SUBJECT: Preliminary & Final Major Site Plan w/ Variance Application No. SP- 8/23  
**Tricone Engineers, Inc.** Grovers Mill Road  
Tax Map Page 42.07, Block 4201.01, Lot 33.03

DATE: June 24, 2024

**Re:** **Tricone**  
**Preliminary and Final Major Site Plan**  
Block 4201.01 Lot 33.03  
Grover's Mill Road & Mall Access Road  
AT-4 (Apartment and Townhouse 4) Zoning District

**SUBJECT:** Grovers Mill Residences, Grovers Mill Road & Mall Access Drive  
Preliminary & Final Major Site Plan, SP-8/23  
Planning Board Memorandum #1  
Lawrence Township, Mercer County, New Jersey  
Tax Map page 42.07, Block 4201; Lot: 33.03

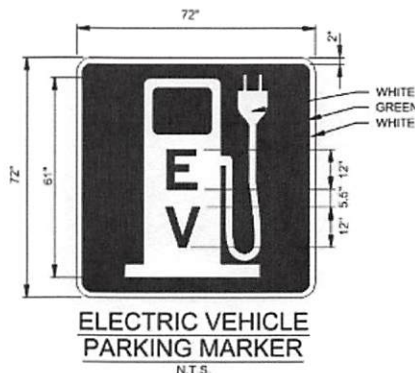
1. On Drawing C1.1, when computing required parking, all fractional spaces should be rounded to the next whole space. The overall EVSE and ADA parking layout should be revised to ensure proper distribution for every building. For example, for Building #F, eight EVSE spaces are assigned, but no ADA surface spaces are provided in front of that building. We recommend reallocating few of

those EVSE spaces from that location to the parking garage underneath Building #F and designate those EVSE spaces as surface ADA spaces.

2. The ADA spaces do not distinguish the van-accessible and are car-accessible, which must be classified in the revised plan set
3. The ADA signs shown on sheet C2.1 are labeled incorrectly, which must be corrected. Moreover, the mounting order of those signs should also be shown correctly. The R7-8 sign (ADA Accessible Reserved Parking Sign) should be mounted at the top, R7-8aP (Van Accessible Plaque) in the middle (when used) and R(NJ)7-8A New Jersey Penalty Plate at the bottom.
4. Please use the MUTCD Standard sign and PANYNJ Standard pavement marking symbol as shown below for the Electric Vehicle Supply/Service Equipment spaces.

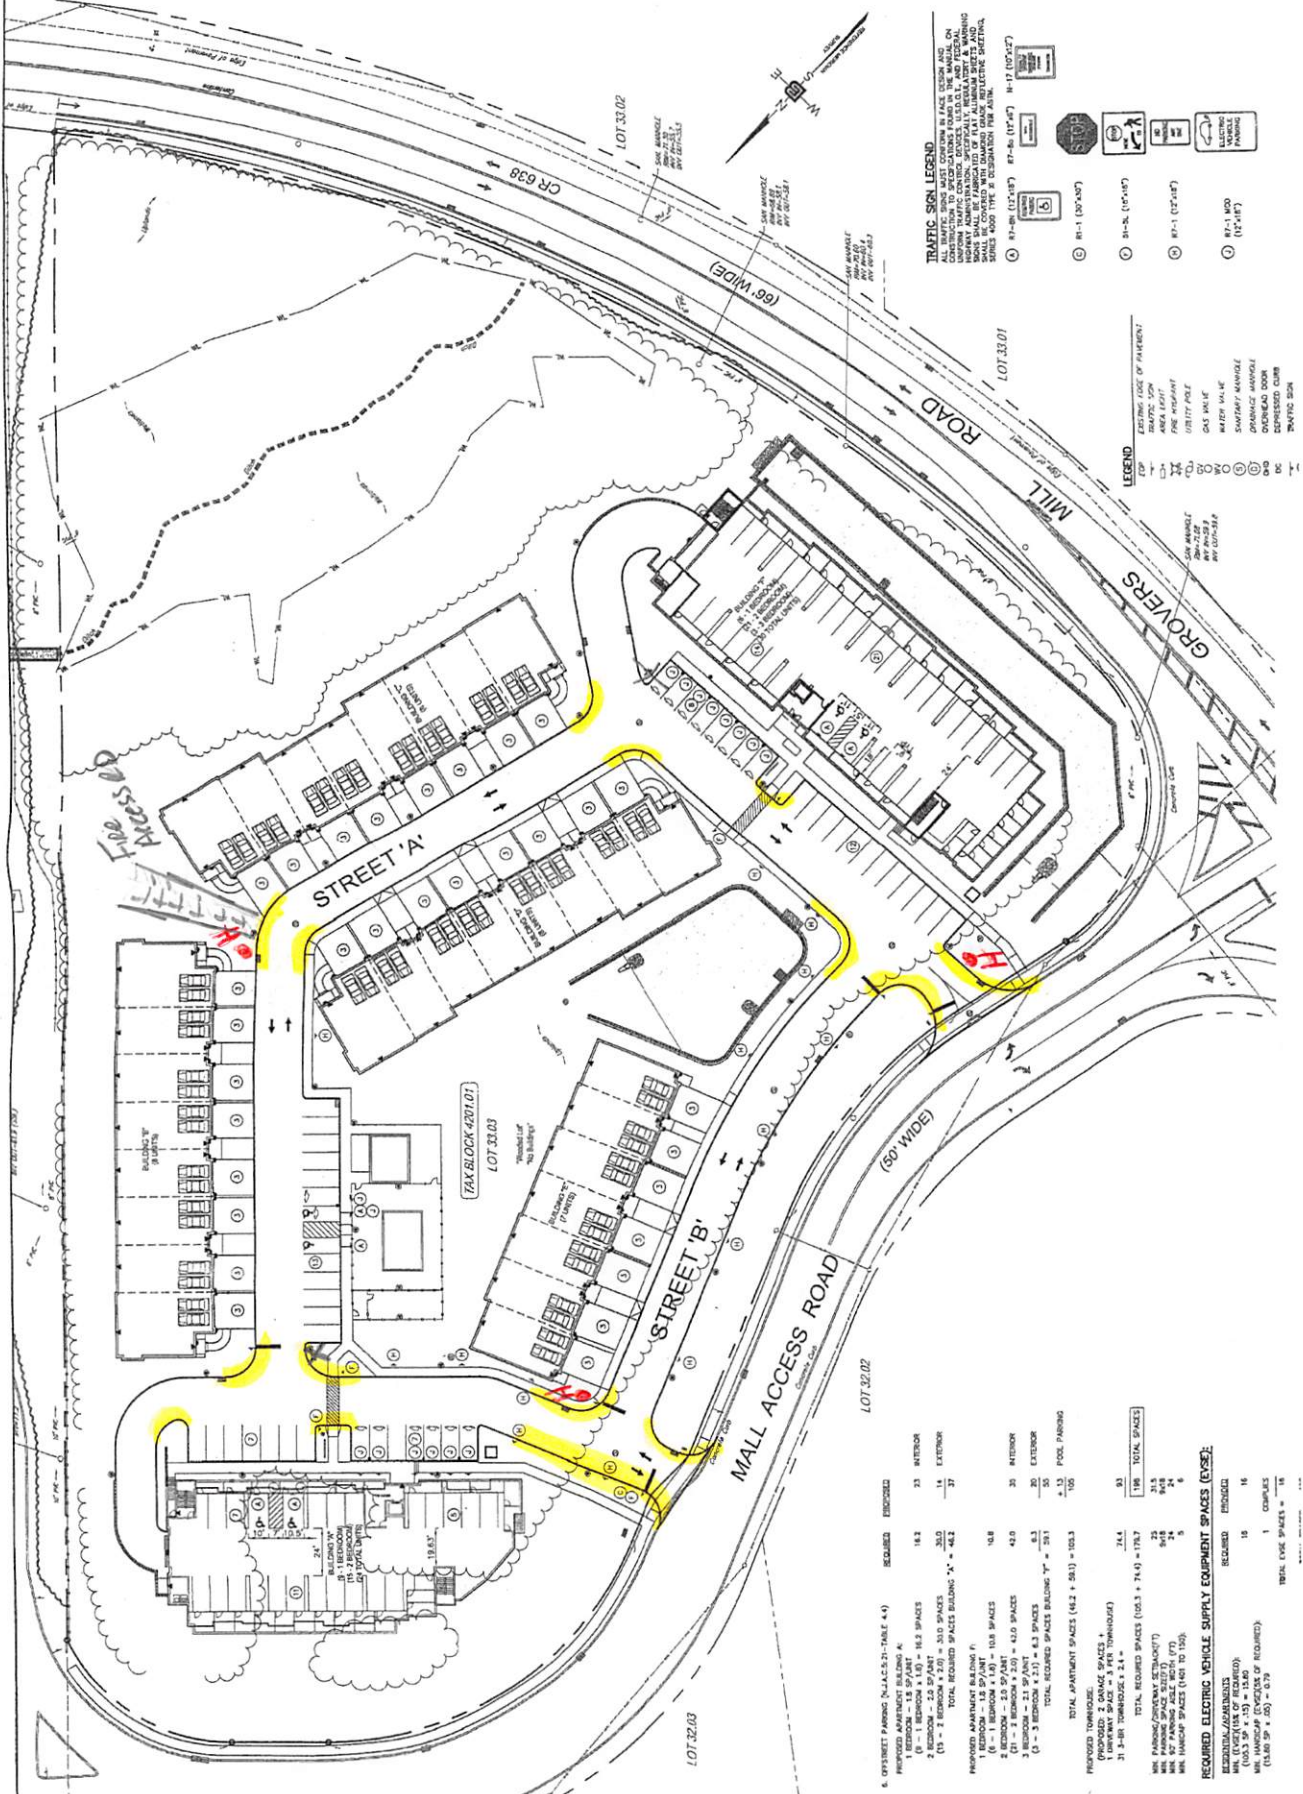
1. Relocation of fire hydrants on property and install additional fire hydrant, as indicated on provided drawing.  
**Hydrant # 1** location at entrance of property closest to Grovers Mill Road off mall access road near Building "F"  
**Hydrant # 2** location between Buildings "C" & "D" on Street "A"  
**Hydrant # 3** location at 2<sup>nd</sup> entrance closest to QuakerBridge Mall at the corner of Street "A" & "B" near Building "E"
2. Fire Access road to Lawrence Township specifications between Buildings "C" & "D" for Ladder Tower access to rear of Buildings "C" & "D" with curb cut.
3. Fire Lane Markings and proper "NO PARKING FIRE LANE" signs to be installed in areas indicated in highlighter on provided drawing.
